**SUBDIVISION COMMITTEE
METROPOLITAN AREA PLANNING COMMISSION**

STAFF REPORT

CASE NUMBER: S/D 91-32 - EAST SIDE BAPTIST CHURCH ADDITION

**STAFF REPORT
(Preliminary Plat)**

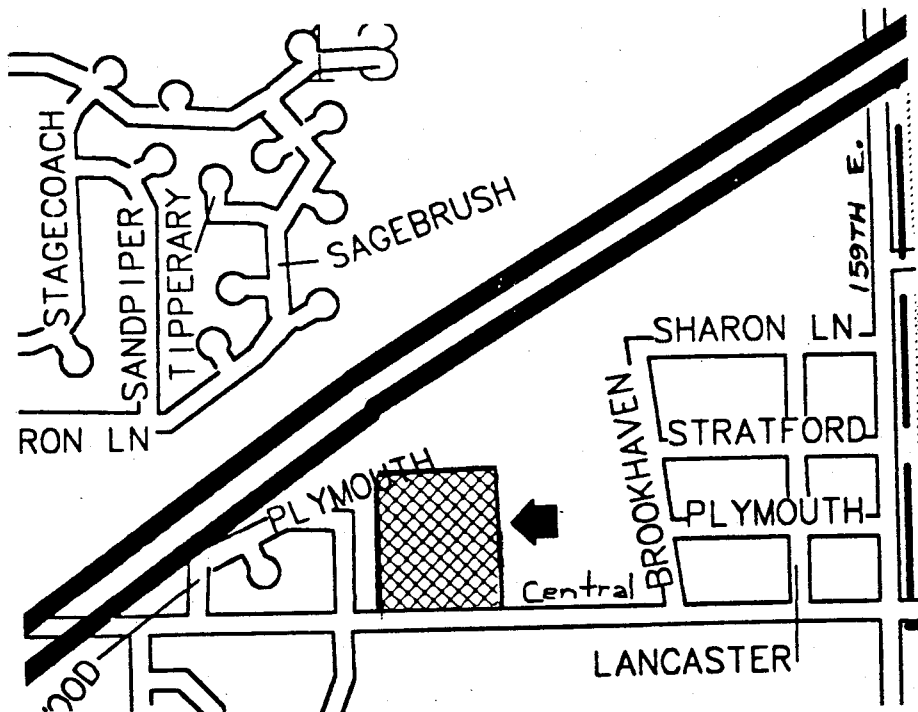
- A. This site is within the Four Mile Creek area and apparently has access to sanitary sewer. However, an existing sewer line to the west of this site is also present. Prior to submitting the final plat, the applicant was to meet with County Engineering to determine how sanitary sewer will be provided to the site. A sanitary sewer layout plan was also to be submitted to County Engineering.

- B. The applicant shall guarantee any drainage improvements required by the platting of this property.
- C. If improvements are guaranteed by petition, a notarized certificate listing the petitions shall be submitted to the Planning Department for recording.

- D. Since this property will utilize a City of Wichita water supply line in Central, the applicant shall submit an outside-the-City water service application and associated restrictive covenant.

- E. The applicant's engineer is advised that the Register of Deeds is requiring the name(s) of the notary public, who acknowledges the signatures on this plat, to be printed beneath the notary's signature.

- F. The applicant shall install or guarantee the installation of all utilities and facilities which are applicable and described in Article 8 of the MAPC Subdivision Regulations.

- G. The applicant's surveyor has indicated that a preliminary sketch has been prepared which shows future plans for residential development in the area surrounding this site and that development will provide needed public access for the area rather than requiring this plat to dedicate right-of-way for such future public access. The applicant shall submit a copy of sketch for this plat's file.

- H. Perimeter closure computations shall be submitted with the final plat tracing. Section 5-101(c).
- I. Recording of the plat within 30 days after approval by the City Council.

- J. The representative from County Engineering should be prepared to comment on the status of the applicant's drainage plan. Engineering should also indicate any requirements for the extension of sanitary sewer to this site.

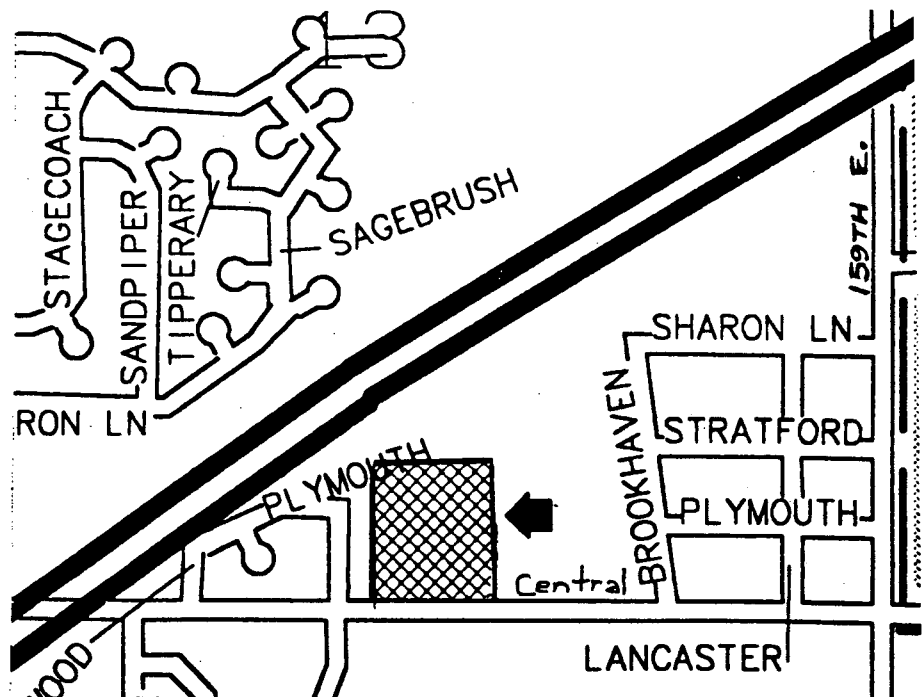
- A. This site is within the Four Mile Creek area and apparently has access to sanitary sewer. County Engineering will need to indicate if Four Mile Creek can be utilized due to poor ground sloping in the area of if other provisions will need to be made to provide sewer.

- B. The applicant shall guarantee any drainage improvements required by the platting of this property.
- C. If improvements are guaranteed by petition, a notarized certificate listing the petitions shall be submitted to the Planning Department for recording.

- D. The final plat shall show the dedication of "access control except for two (2) openings" along Central and the platator's text shall reference the dedication.

- E. Prior to or at the time of submitting the final plat, the applicant shall submit a drainage plan to County Engineering for review and approval.
- F. If required for this site, minimum building pad elevations shall be indicated both on the face of the plat and referenced in the platator's text. Both on-site and off-site bench marks shall be shown. It shall also be indicated if the minimum elevation involves the lowest floor or opening elevation.

- G. Requirements for a final plat (see pages 24-29, Part 4, Article 5 of the MAPC Subdivision Regulations).
- H. The applicant's engineer is advised that the Register of Deeds is requiring the name(s) of the notary public, who acknowledges the signatures on this plat, to be printed beneath the notary's signature.

- I. The applicant shall install or guarantee the installation of all utilities and facilities which are applicable and described in Article 8 of the MAPC Subdivision Regulations.

- J. The representative from County Engineering should be prepared to comment on the status of the applicant's drainage concept.
- K. The representatives from the utility companies should be prepared to comment on the need for utility easements to be platted on this property.

- L. County Engineering needs to comment on the appropriate number of openings onto Central.

- M. The final plat should more clearly show the 50 foot of half street right-of-way for Central.
- N. On the final plat, the applicant will need to dedicate 35 feet of half street right-of-way along the east line of this plat to provide for future development and access to the north of this plat. A 25 foot building setback will need to be platted along the street being dedicated. The final plat shall reference, in the plat's text, the dedication of the street to and for the use of the public.
- O. County Engineering needs to indicate if a half street of right-of-way will need to be dedicated along the east line of this plat to provide for future development and access to the north of this plat.
